Agenda Item 4

ADDENDUM MEETING OF THE PLANNING COMMITTEE WEDNESDAY 31st NOVEMBER 2018

18/01134/F - Land To The Rear Of 19-29 Shelvers Way, Tadworth

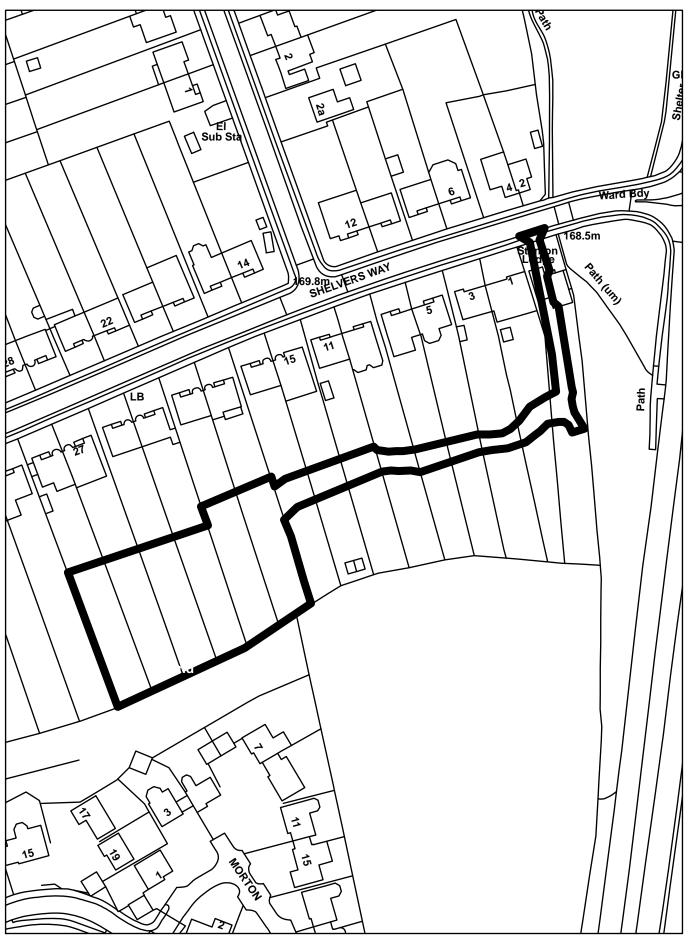
Site Plan

A site plan showing the correct application site boundaries is to be found at the Appendix A. This supersedes the plan on page 106 of the agenda.
